# **Public Hearing Testimony**

October 2004 Carnation Wastewater Treatment Facility Final EIS 84

# Wittrock (H1)

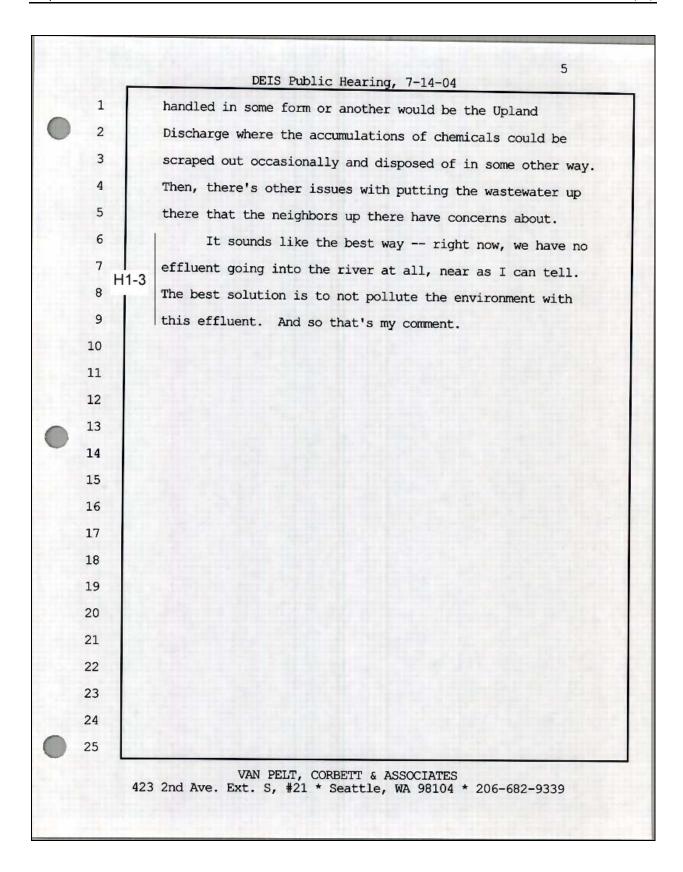
DEIS Public Hearing, 7-14-04
1		
2		STATEMENT OF PAUL WITTROCK
3		
4		I am Paul Wittrock, 10810 298th Avenue Northeast in
5		Carnation, 98014.
6		Thank you, King County, for coming out. And my
7		concerns are regarding the treatment plant processing of the
8		wastewater, the effluent. It sounds like you're doing a
9		good job of taking out the biological components.
10		But the analysis that King County performed comparing
11		the wastewater effluent to drinking water which is often
12		the comparison that is made, holding up clear glasses of
13		water, of effluent, and comparing them to drinking water
14	H1-1	your analysis showed that there is extremely high levels of
15		chemicals in solution in this wastewater. Household wastes,
16		cleaners, industrial things that are used in commercial
17		processes in the cities that have sewers aren't taken out by
18		your process. At least you didn't explain that they were.

19		So I'd like to ask, if you could tonight, to touch on
20		that and show and tell us if they are removed because it
21	H1-2	sounds like you're either, A, going to put these in the
22		river, in Stillwater Wildlife Area where they would
23		bio-accumulate. The animals, creatures there would be
24		exposed to these ongoing accumulations of chemicals.
25		And the only thing that sounds like they could be
	423	VAN PELT, CORBETT & ASSOCIATES 3 2nd Ave. Ext. S, #21 * Seattle, WA 98104 * 206-682-9339

### **Response to Comment H1-1**

The EIS shows drinking water standards in Table A-11 in Appendix A. That table compares water quality standards established by the State of Washington for the chemicals listed. The table is not a list of chemicals expected to be present in the highly treated water discharged from the Carnation Wastewater Treatment Facility. Rather, the table shows acceptable levels of the listed chemicals in surface, ground and drinking waters in the State of Washington, whatever the source of those chemicals might be.

In Chapter 6, Section 6.2, the Draft EIS discusses the potential impacts and mitigation measures of discharging the highly treated water to the environment. In particular, the discussion of chemical contaminants beginning on page 6-23 points out that organic chemicals (e.g., those found in household cleaners) typically enter the waste stream in small quantities and that most would be removed by the treatment process.

In Chapter 1, Section 1.9.2, the EIS explains why King County's design of and policies for the Carnation Wastewater Treatment Facility would ensure that the highly treated water discharged from the facility would meet or be better than regulatory standards. These include the high pollutant removal achieved by the MBR process, regulatory restrictions on the types and amounts of potentially harmful materials that Carnation businesses would be allowed to discharge to the sewer system, and the County's policy of complying with all applicable permit standards now and in the future.

### **Response to Comment H1-2**

As described in the response to the previous comment, the Carnation Wastewater Treatment Facility would achieve a high level of pollutant removal. This level of removal would produce water that meets or is of higher quality than State water quality standards. These standards are designed to protect aquatic life from bioaccumulation of listed contaminants. King County continuously monitors the scientific literature for chemicals that are of concern that don't have water quality standards. King County also takes water samples from various parts of its service area and analyzes these samples for many of these chemicals. King County would monitor the highly treated water discharged from the treatment plant to meet regulatory requirements. For these reasons and for the other reasons given in Chapter 7, Section 7.2.2.2, the impacts of discharging highly treated water to the wetlands are expected to be insignificant.

## **Response to Comment H1-3**

As indicated in Chapter 6, Section 6.1.2.1, agricultural, residential and silvicultural areas have been documented as nonpoint sources of pollutants throughout the lower Snoqualmie River system. And as indicated in Chapter 6, Section 6.2.5, if the treatment facility were not built, the risk to surface and groundwater quality would continue at present or increased levels as aging septic systems continued to fail. Finally, as stated in Chapter 6, Section 6.2.3.1, the combination of low pollutant levels in the highly treated water discharged from the plant and rapid dilution in the river are expected to result in no significant adverse impacts to the river's water quality.
